**81 SOUTH CEDAR CREST
MAJOR PLAN 2023-107**

TO: PLANNING COMMISSION
FROM: GREGG R. ADAMS, PLANNER
SUBJECT: 81 SOUTH CEDAR CREST
MAJOR PLAN 2023-107
REQUEST FOR SKETCH PLAN REVIEW

SUBJECT: South Whitehall Township
 81 South Cedar Crest
 Major Plan #2023-107
 Sketch Plan Review

REVIEW COMMENTS

Drawing No.
CP3

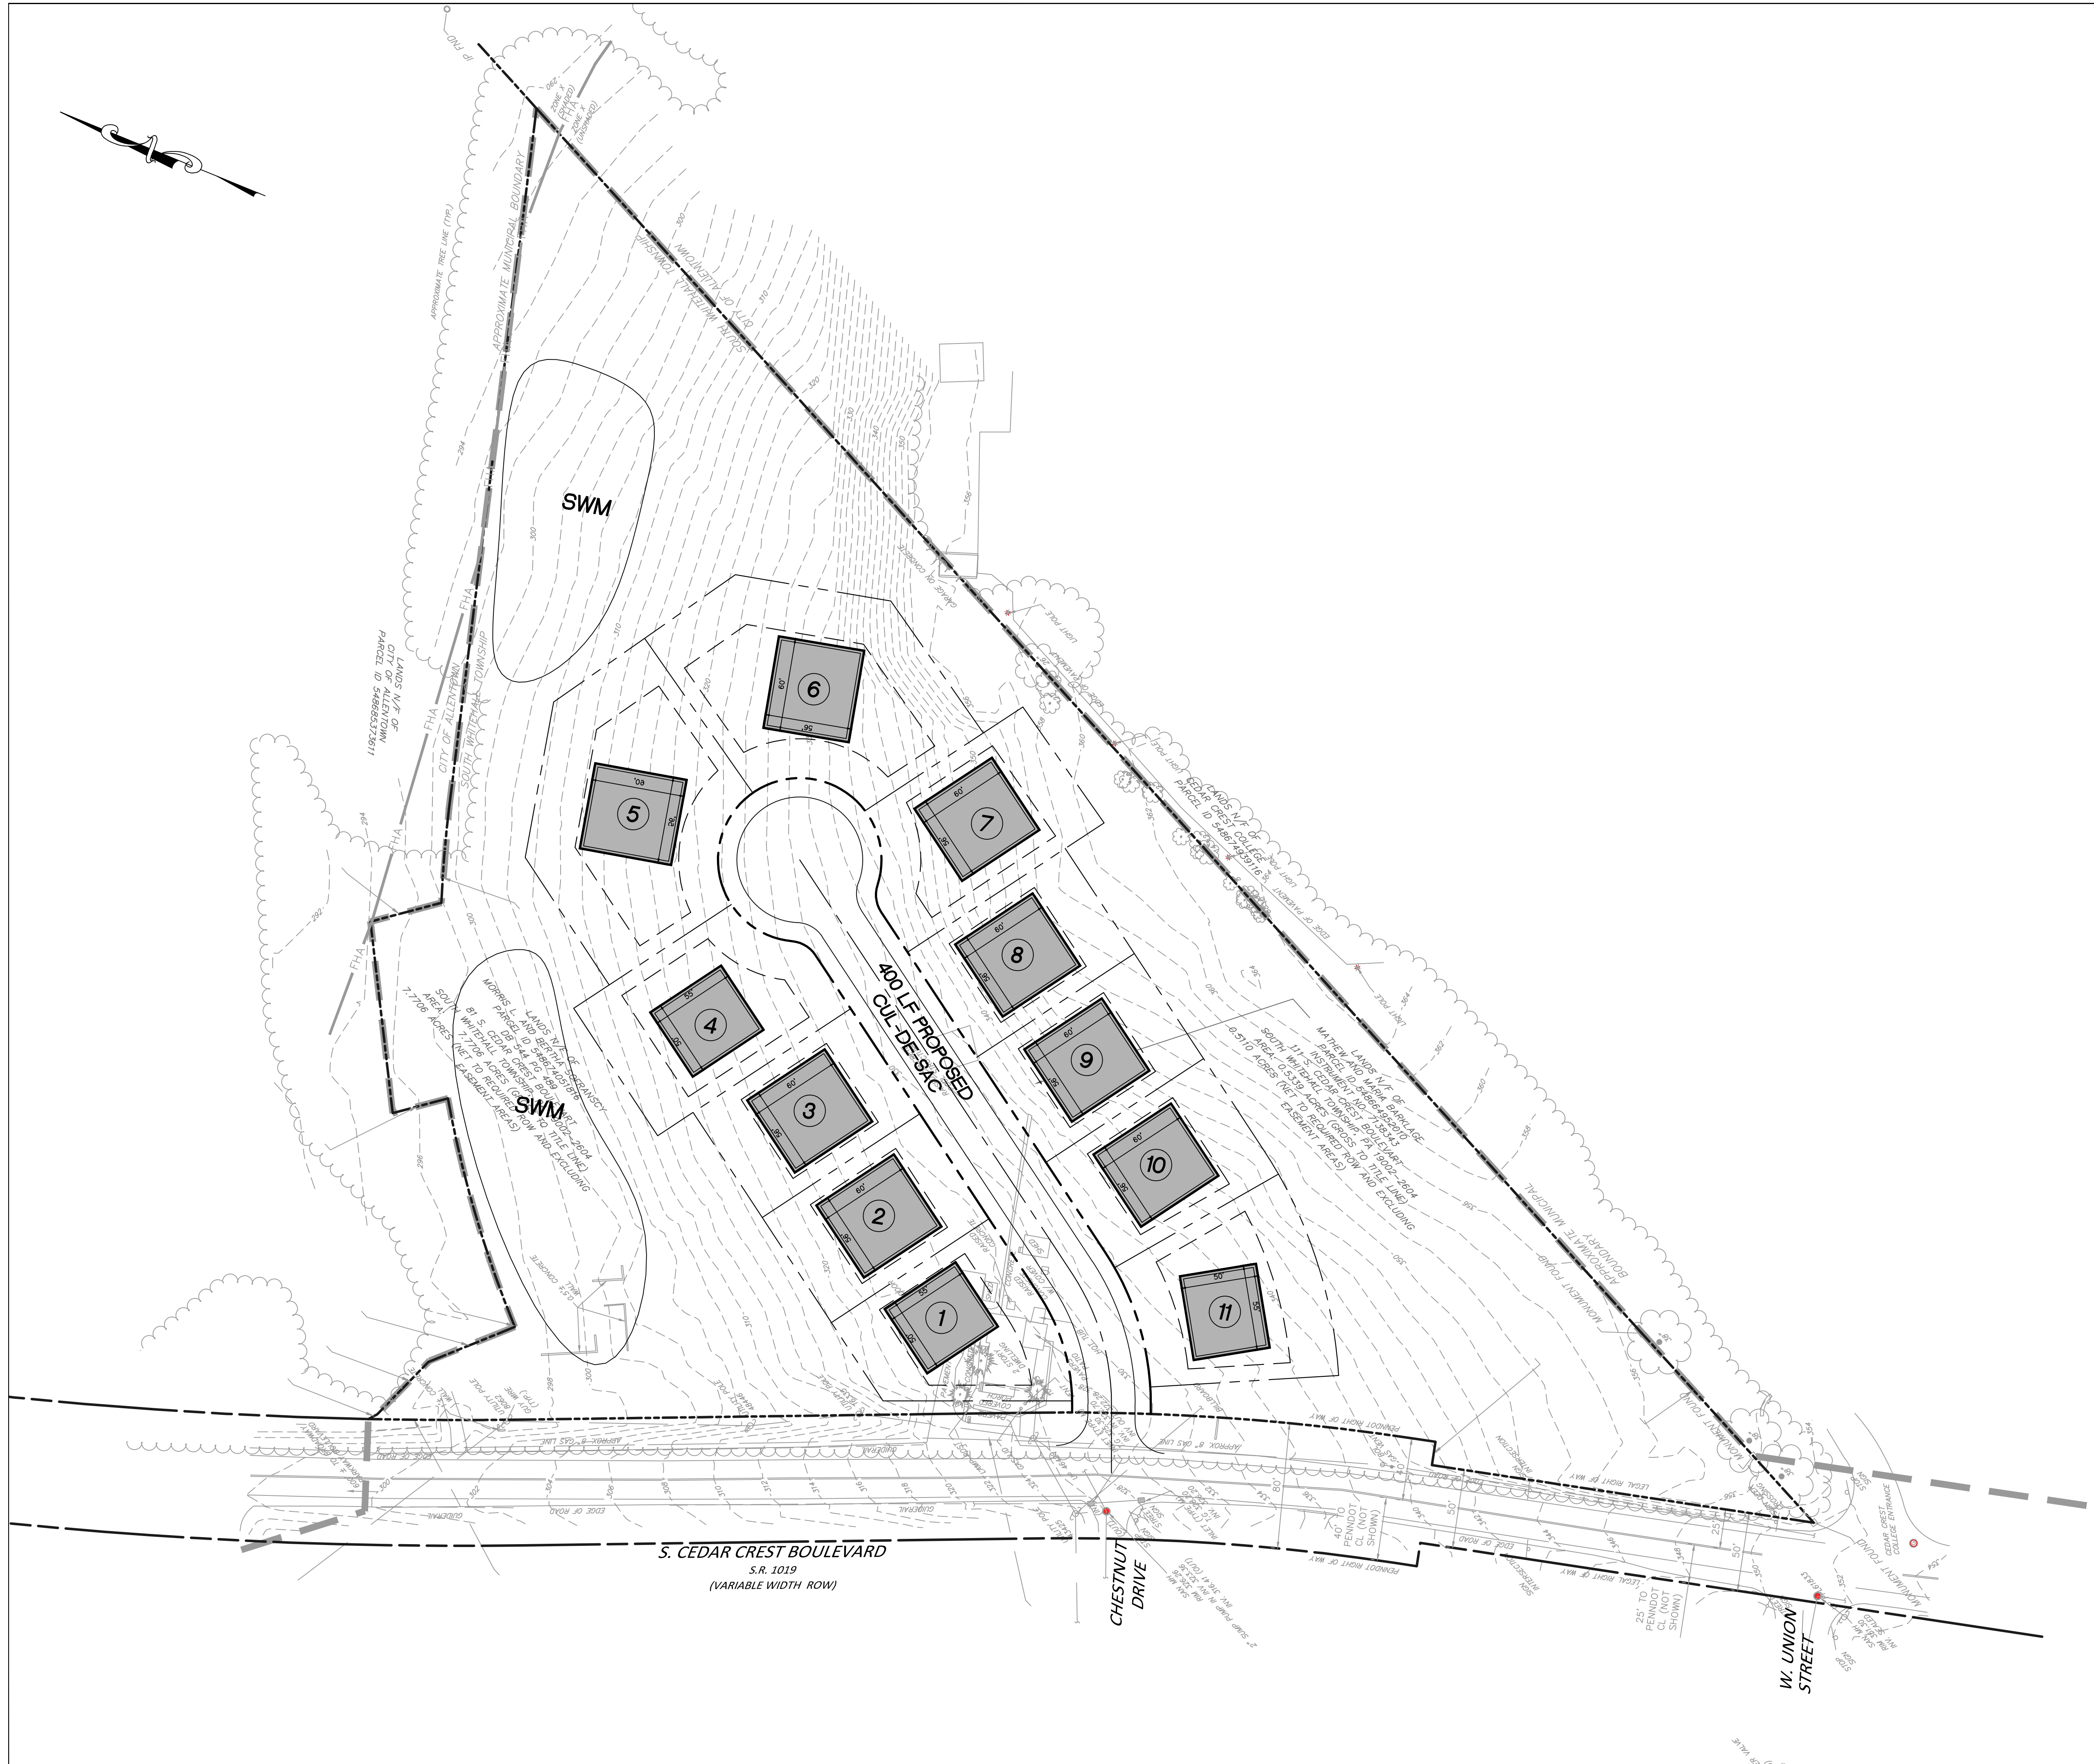
1. The project is located in the Little Lehigh Creek Watershed Act 167 Subareas 192 and 199 which are 30/50 and 30/100 percent release rate districts respectively. Stormwater management system plans and design calculations which demonstrate that the proposed development will meet the Act 167 runoff requirements and the water quality volume (WQv) requirements for discharge to any contiguous properties for each discharge point should be submitted for review with the Preliminary Plan. It should be noted that the Little Lehigh Creek Act 167 lists several Significant Obstructions (Nos. 152 through 155) downstream of the site;

2. The following improvements along the property frontage are required along Cedar Crest Boulevard and the proposed cul-de-sac per the SALDO: right-of-way dedication, cartway widening, curb, sidewalk, monuments, shade trees, etc. (SALDO §312-26(a) §312-35(b), §312-36, and §312-40 pertain), and should be shown on the Plans. Per ZO §350-42(t), show the ultimate right-of-way along Cedar Crest Boulevard 50 feet from the centerline. Any improvements along Cedar Crest Boulevard and the proposed intersection to the site are to be reviewed and permitted by PennDOT;

3. Provide floodplain mapping per FEMA and obtain any applicable permits for work within the existing floodplain, SALDO §312-10(b)(14);
4. We recommend investigating a connection to the Cedar Creek Path to provide pedestrian connectivity from Cedar Crest College to the Park;

5. Provide truck turning templates (trash, fire, and delivery) for the site as part of the Preliminary Plan submission to demonstrate the roadway radii are adequate to handle trucks entering and exiting the site without impeding oncoming traffic. In addition, truck turning templates should be provided demonstrating the ability of trucks to maneuver through the site;

6. Address the following Sketch Plan related comments:
 - a. Provide a signed statement that the applicant is the owner, or authorized by the owner to make an application for the land should be provided on the Plan, SALDO §312-10(b)(4);

- b. Expand the Zoning Data Table to include the area in square feet or acres for each lot, the linear feet of new road, impervious cover, and driveway separation measurements SALDO §312-10(b)(5)(B), §312-10(b)(5)(C), and §312-10(b)(5)(H);

- c. For clarity, label the site, identify the floodplain, and clarify the street names on the Location Map, SALDO §312-10(b)(6);
 - d. Dimension the front, side, and rear yard setbacks and proposed right-of-way, SALDO §312-10(b)(9). It appears that Lots 1 and 11 may be corner lots and have 2 front yard setbacks;

- e. Provide property boundary information within the site and within 200 feet of the site, SALDO §312-10(b)(10). We note that the Barklage lot line information is not clear;

- f. Show any proposed staging, SALDO §312-10(b)(11);
 - g. Identify significant physical and topographical features including the floodplain and its basis, (e.g., Panel 42077C0234F, revised July 16, 2004), wetlands, water conservation areas, steep slopes, and woodlands, SALDO §312-10(b)(12);

- h. Provide Plans to LANTA and United States Postal Service, SALDO §312-10(a)(6) and §312-10(a)(7);
 - i. As indicated on the Official Map – Component 1, the site is located within woodlands. Subsequent plan submissions should be reviewed by the Township Geotechnical Consultant to cover geotechnical matters including slope stability, SALDO §312-10(b)(14);

- j. Identify the intended use or removal of any existing facilities (e.g., existing dwelling, existing billboard, etc.) in the narrative and on the plans, SALDO §312-10(b)(14);

- k. Contact the Parkland School District to determine suitable locations for school bus stops and incorporate same into the Preliminary Plans, SALDO §312-10(b)(14); and

- l. Consider providing buffering/screening of the existing Cedar Crest College parking area/facilities to the east, SALDO §312-10(b)(14) and ZO §350-42(b).

7. We note the following as it relates to the proposed cul-de-sac:
- a. Although the proposed cul-de-sac does not meet the required 800-foot offset along Cedar Crest Boulevard from Union Street, SALDO §312-35(a)(6)(E)(i), its centerline will align with existing Chestnut Street (directly opposite Cedar Crest Boulevard). A waiver from this requirement may be necessary;

- b. Revise the cul-de-sac to meet all Township Local Street Standards (e.g., 60-foot right-of-way required (50-foot proposed), 36-foot cartway required (30-foot proposed), curbing (none proposed), sidewalk (none proposed), street trees (none proposed), etc.), SALDO §312-35(b)(3)(D);

- c. Revise the design of the cul-de-sac to provide a 100-foot tangent between the curve and the street intersection (50-feet± provided), SALDO §312-35(b)(3)(A)(v);

- d. Provide a snow drop off area per SALDO §312-35(b)(2)(B)(iii);
 - e. Required and available sight distances and lines based on PennDOT intersection sight distances as well as the Township Clear Sight Triangles should be provided on the Preliminary Plans, SALDO §312-35(a)(6)(F). The required sight distances should be depicted using sight lines and the available sight distances should be labeled on the plans;

- f. Identify driveway locations to confirm driveway offsets are met per SALDO §312-36(c)(4)(A);
 - g. Add a note subsequently to the Preliminary Plans indicating that lots which contain frontage on Cedar Crest Boulevard and to the proposed cul-de-sac should take access from the interior roadway, SALDO §312-36(b)(5); and

- h. A Highway Occupancy Permit will be required for the proposed cul-de-sac location along Cedar Crest Boulevard, SALDO §312-36(c)(1). All correspondence with PennDOT should be provided to South Whitehall Township and our office.

9. Address any concerns of the Landscape and Shade Tree Commission, specifically as it relates to any tree protection areas, buffering, etc.;
 10. The Township should determine whether open space, or fees in lieu of, will be required, and an appropriate note should be placed on a Preliminary Plan, SALDO §312-34(d). The Project Narrative indicates each lot shall be 9,600 square feet with the area surrounding the lots remaining as open space. Identify, ownership and maintenance responsibilities for the open space;
